DA40 IPC

8. Description of Work Accomplished

N777ZV

replace with #54-063 rocker switch (SPDT) * THIS will fit the panel cut out.
R| Fig 08 Switches - IFR

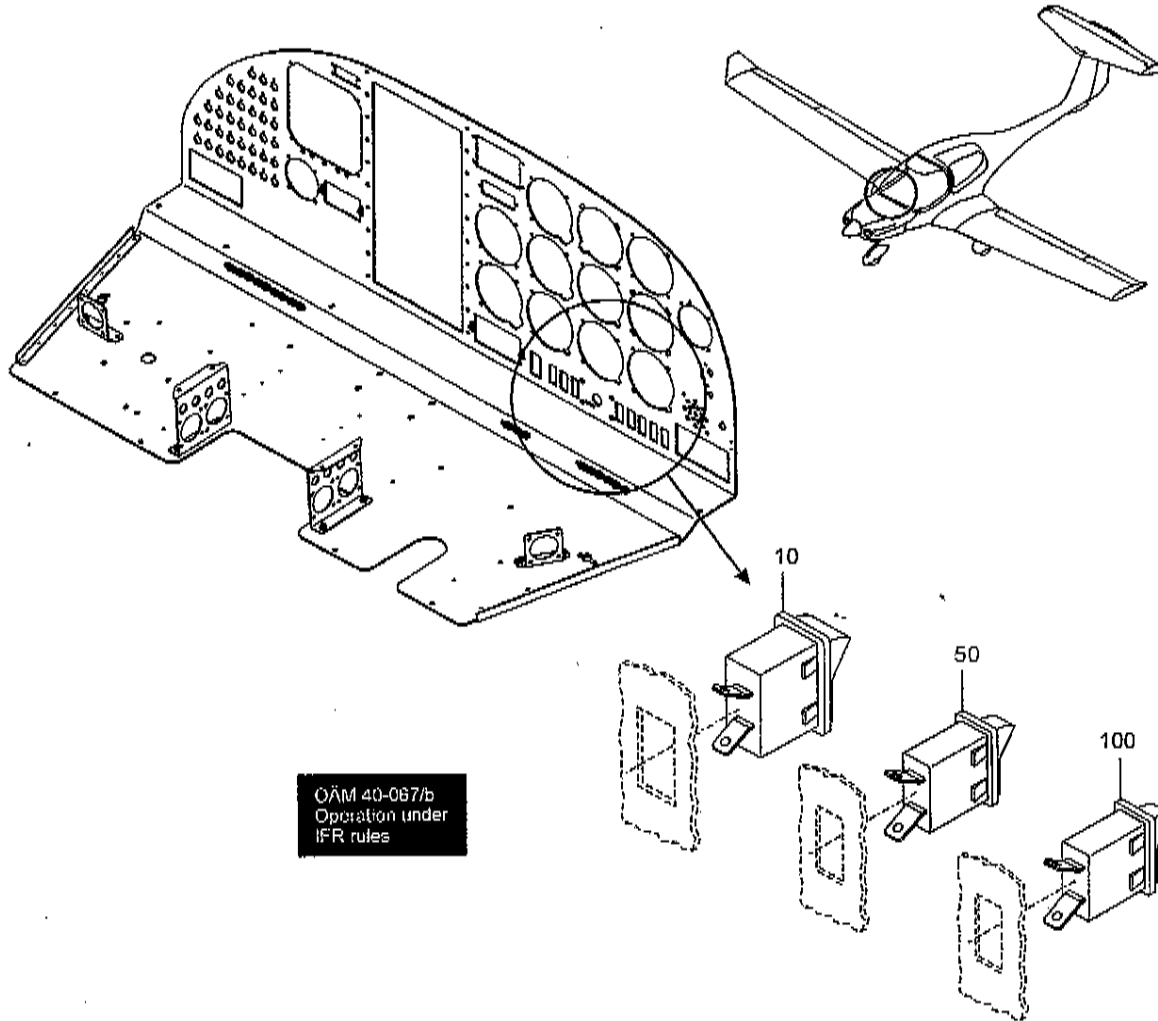
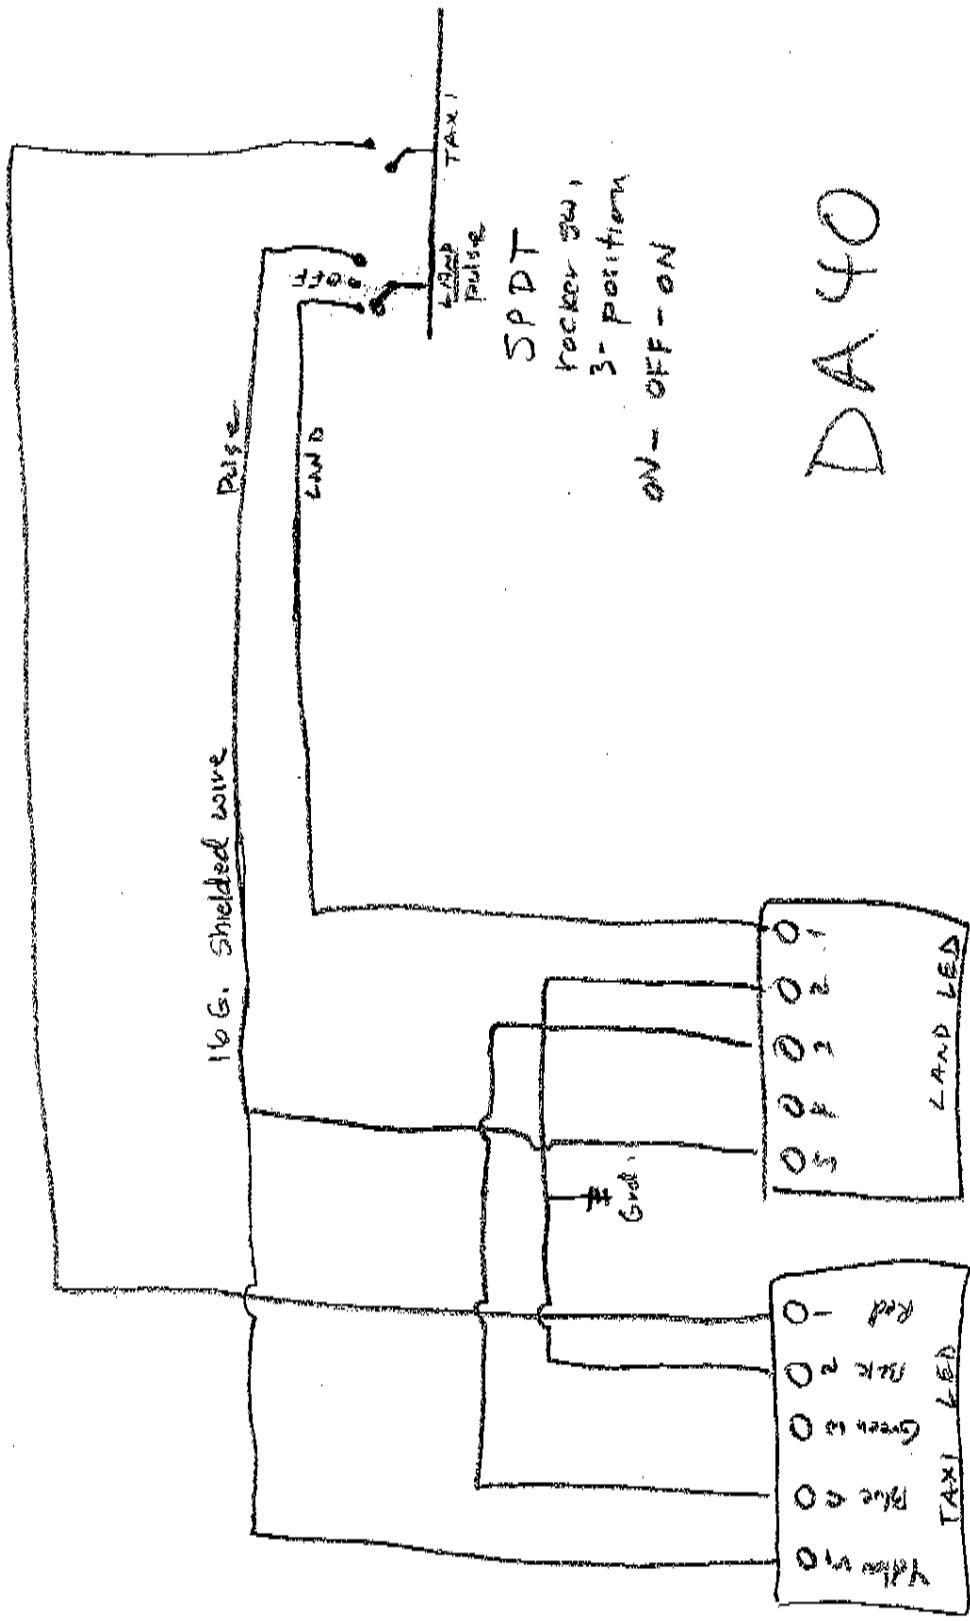
SPDT
 rocker sw,
 3- position
 ON - OFF - ON

R| Fig 03 Wings

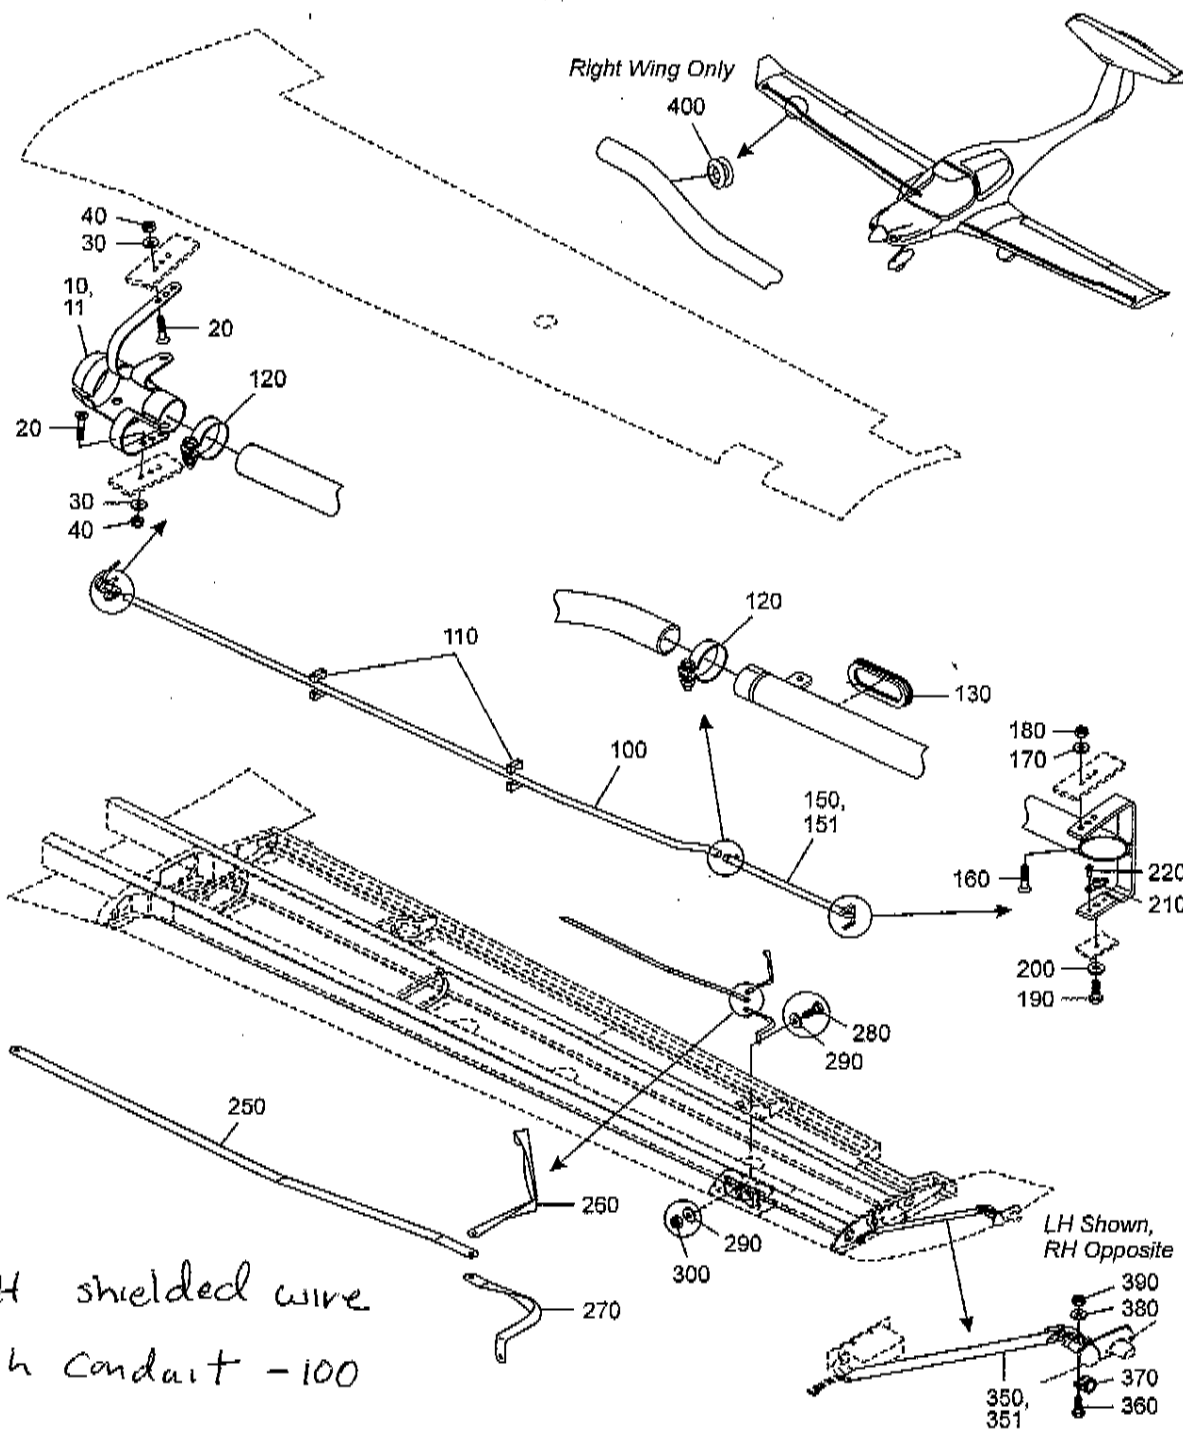
Removed (2) ea. original equipment landing / taxi lamps. Whelen P/N 01-0770346-01 (quartz halogen). Installed (2) ea. Aero-LED's P/N 90-1000 (Sunbeam). FAA-PMA approval number PQ5259NM in original location L/H wing. Used existing mounts/brackets. Replaced landing light control switch with similar rated 3-position rocker switch, SPDT P/N 54-063. The new switch functions are (normal) landing - off - pulse. The pulse feature will operate both LED assy. in a alternating "on-off" fashion. Used existing 5 amp circuit breaker. Referenced AeroLED's installation guide Doc. 0013-0004, rev.1R, pg. 1-6. ICA is included with document. The taxi light function and control will remain the same. Updated equipment list. Weight change negligible.
